[Nave - 1853 / 1856]

The seating in the northeast block of pews is being altered as follows:

[Loose Benches]

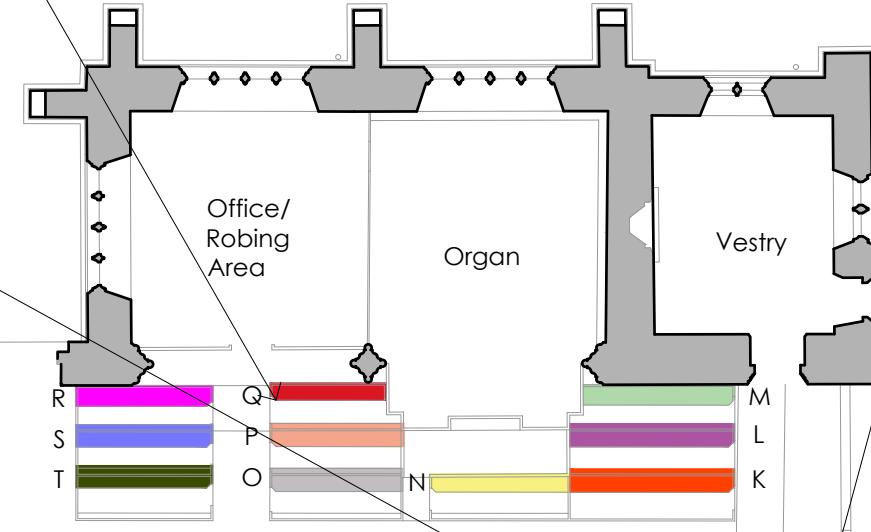
A minimum of two of the existing loose benches at the west end of the church will be retained, subject to confirmation of their provenance and historical interest by the findings of the pew survey. Location to be verified.

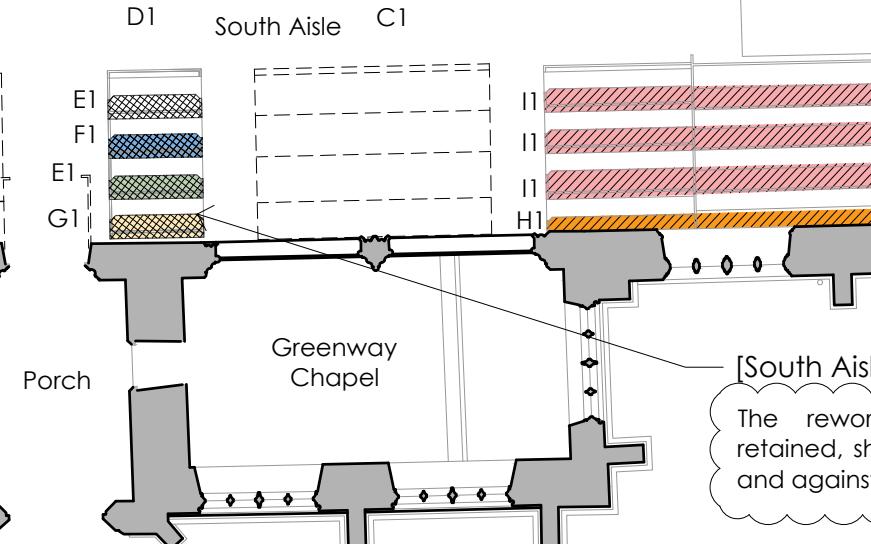
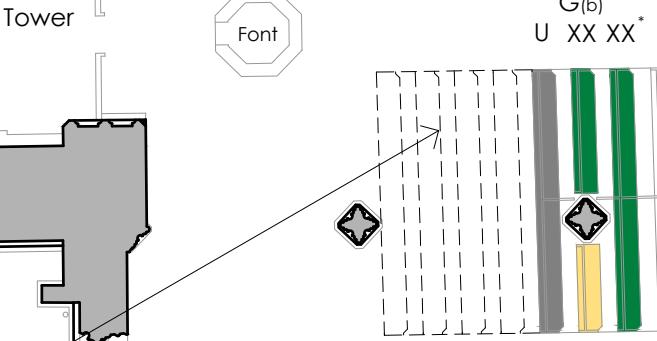
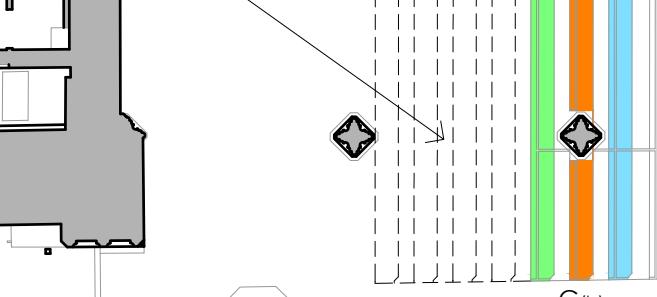
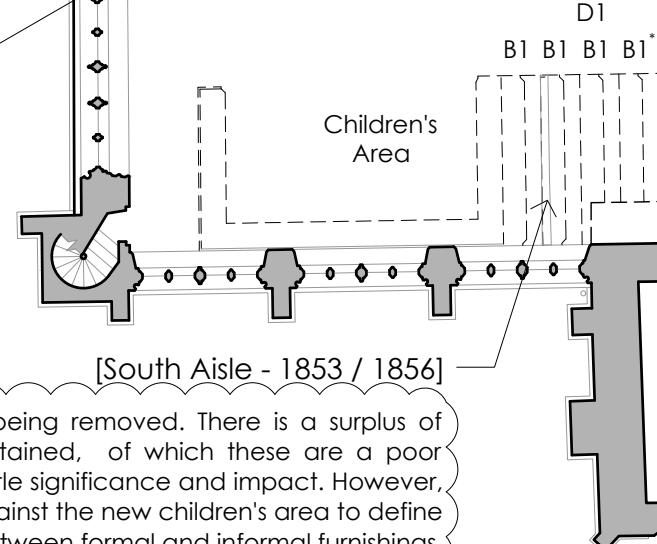
- The changing of type J pew for a type F.
- The removal of a type F pew.
- The removal of a type G(a) pew.
- The removal of a type G(b) pew.
- The removal of a type FF pew.

All the south facing Ashworth pews are being retained.

2 type A and 2 type B pews are being removed. With 1 example of an Ashworth type B pew being replaced for a type A pew.

There are several changes proposed to the rear of the north west collection of pews, this includes:

- The changing of a type C for a type FF.
- The removal of a type D.
- The changing of a type D for a type FF.
- The changing of a type E for a type F.

In addition, two rows of "free seats" (pews without doors) are to be retained and relocated to the west end of the new reduced pew layout.

There are several changes proposed to the rear of the south west collection of pews, this includes:

- The changing of a type U for a type X.
- The removal of a type X.
- The changing of a type V for a type A1.
- The changing of a type W for a type A1.

The seating in the southeast block of pews is being altered as follows:

- The removal of two type A1 pews.
- The removal of a type B1 pew.
- The removal of a type C1 pew.

[Late 19C.]
The rectorial pews are to be retained.

[Early 19C.]
The Mayoral Pews are being retained.

The reworked Ashworth pews in the south aisle are being removed. There is a surplus of examples representing Ashworths reordering being retained, of which these are a poor example. The loss of this group of pews is therefore of little significance and impact. However, the frontal will be retained on the back line of pews, against the new children's area to define the line across the church between formal and informal furnishings.

The reworked Ashworth pews are being retained, shortened and relocated further west and against the glazed entrance lobby.
